**CITY OF WESTFIELD, IN**  
**Advisory Planning Commission Meeting Agenda\_05\_02\_2016**

**Monday, May 02, 2016 at 07:00 PM**

WESTFIELD-WASHINGTON TOWNSHIP  
ADVISORY PLAN COMMISSION

WESTFIELD-WASHINGTON TOWNSHIP  
ADVISORY PLAN COMMISSION

| SCALE                                                                                 | 1"=40'-0" | RETREAT ON THE MONON<br>PERIMETER LANDSCAPE PLAN |  |

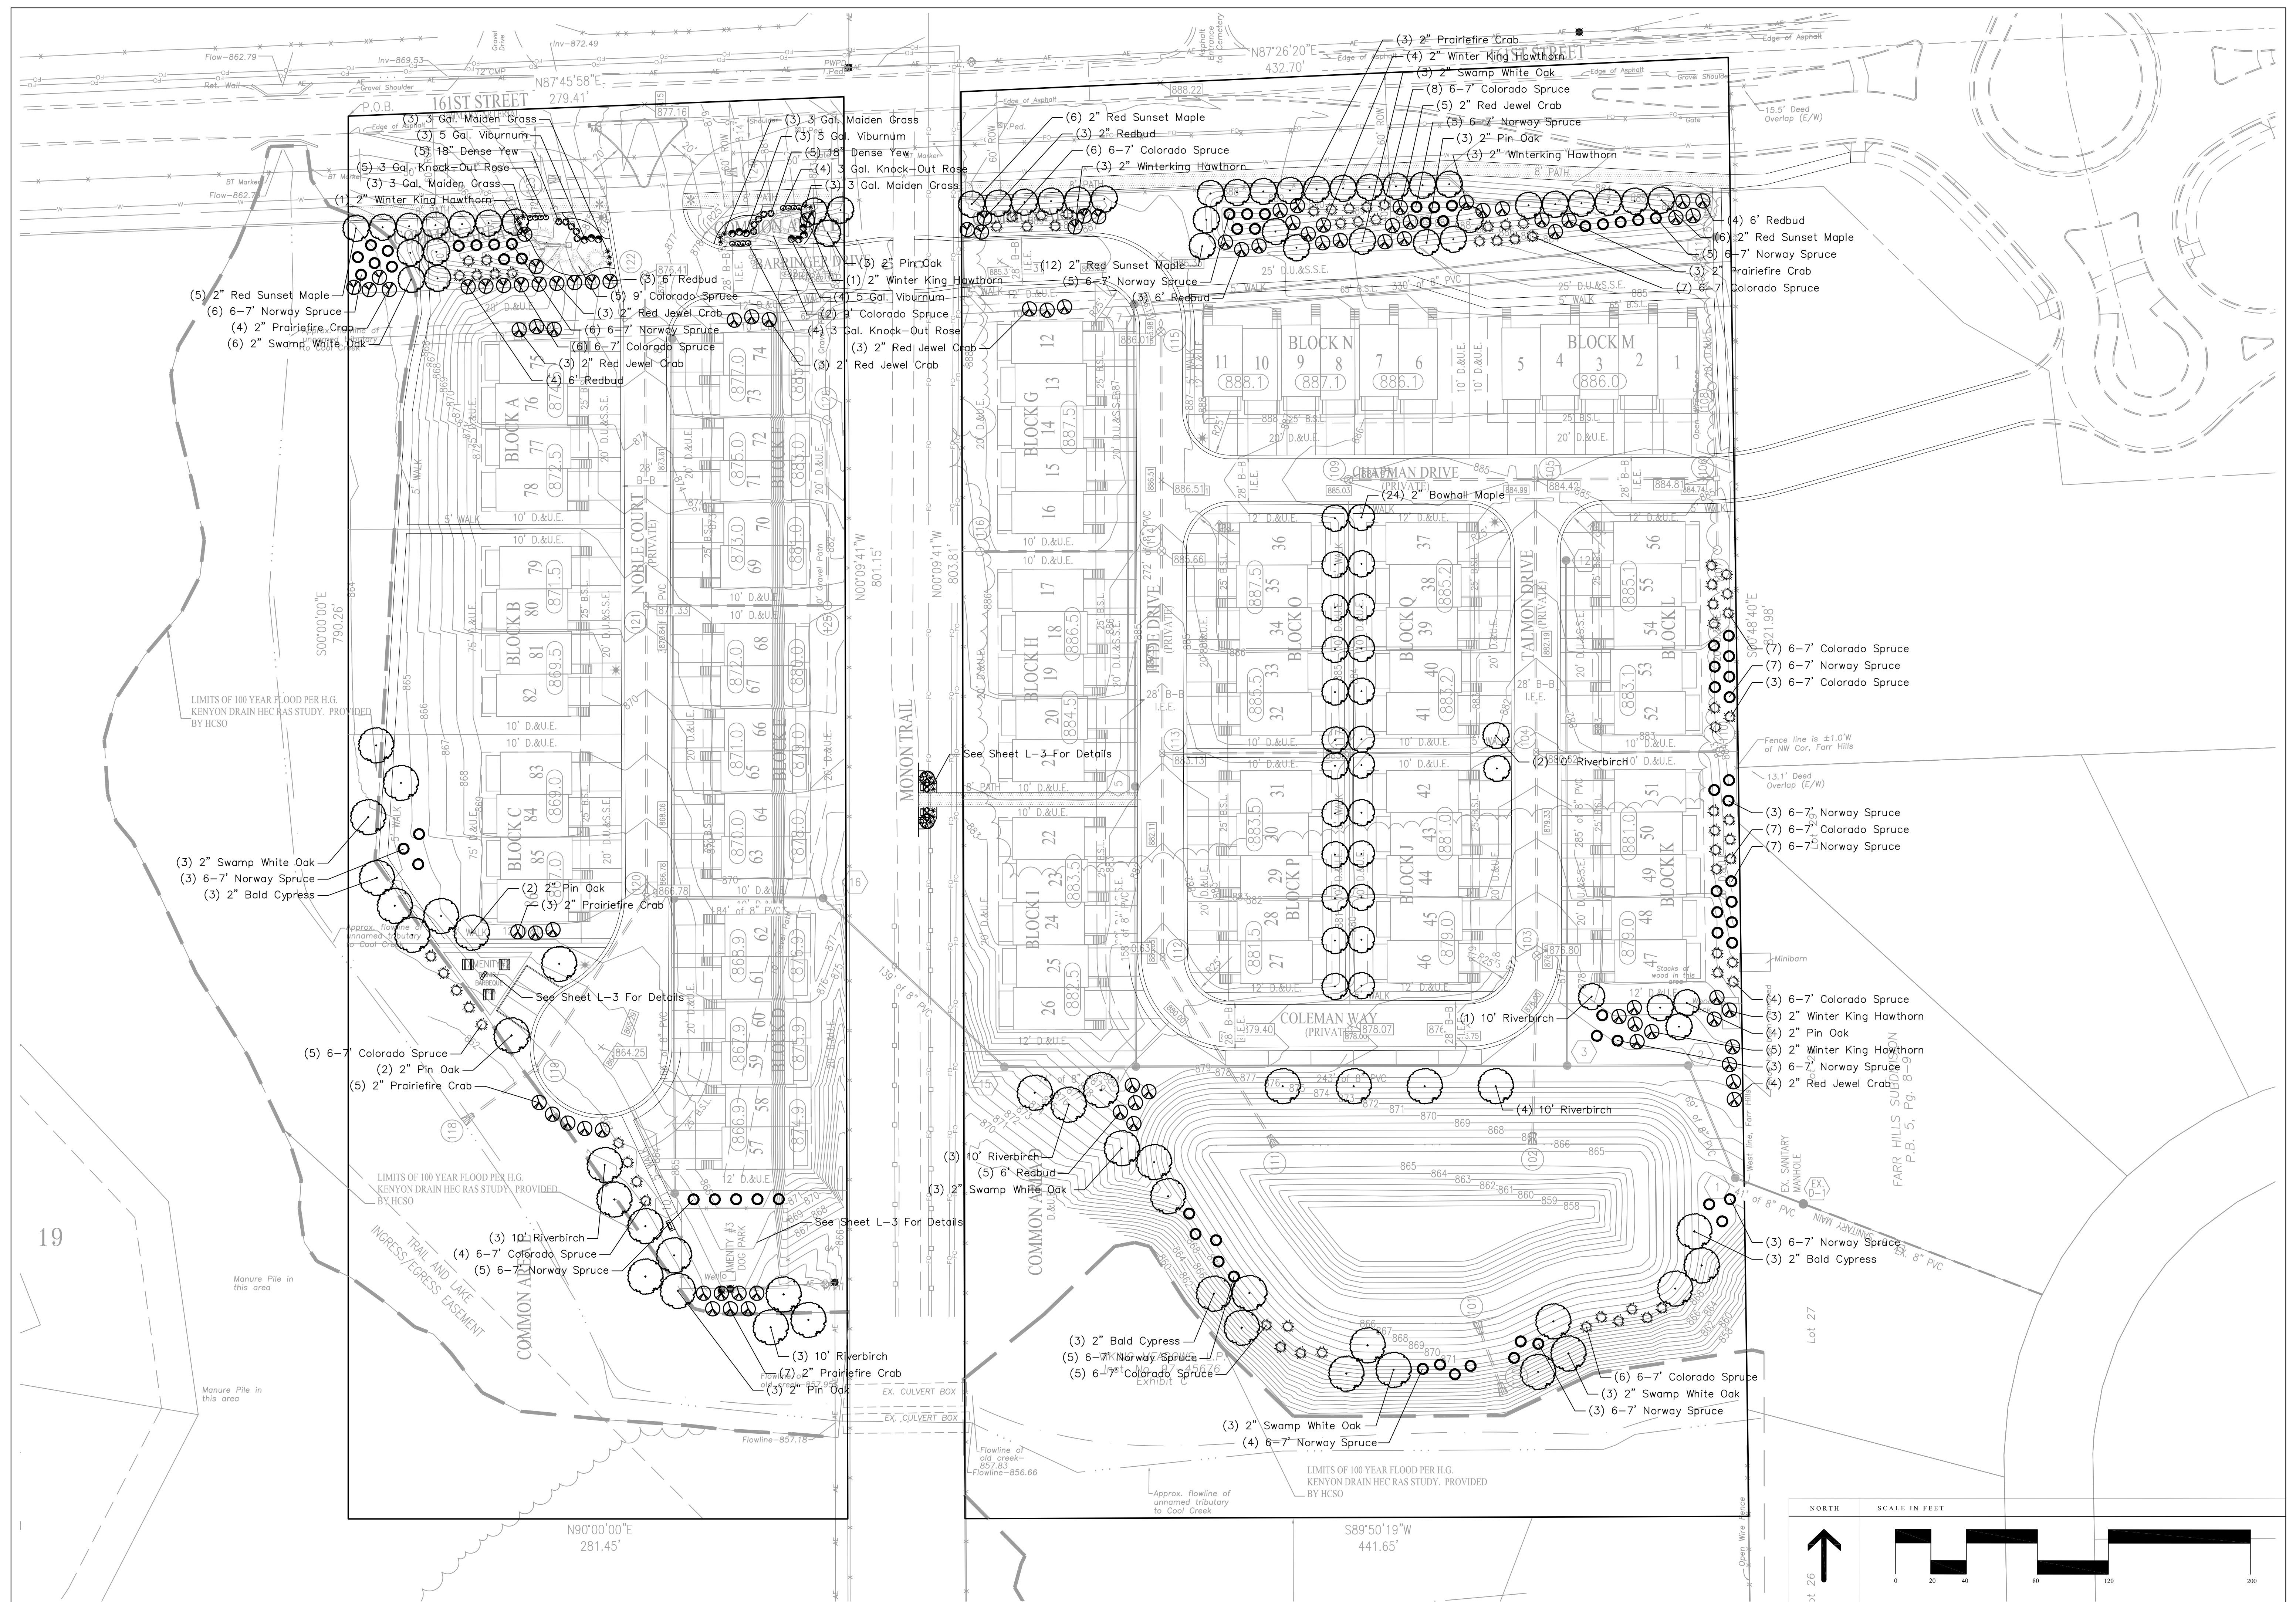
- a) Please correctly label shade trees in plant list.
- b) Please include entry wall details on the landscape plan (e.g., height, materials).
- c) Please show proposed landscaping on Entrance Area Enlargement (Sheet L-2).

**Comment:** Landscape plan needs revised to incorporate additional shrubs as follows:

**Comment:** Plans comply. Please darken mound lines for legibility and label mound locations on landscape plan for clarity with reference to mound detail on Sheet L-2.
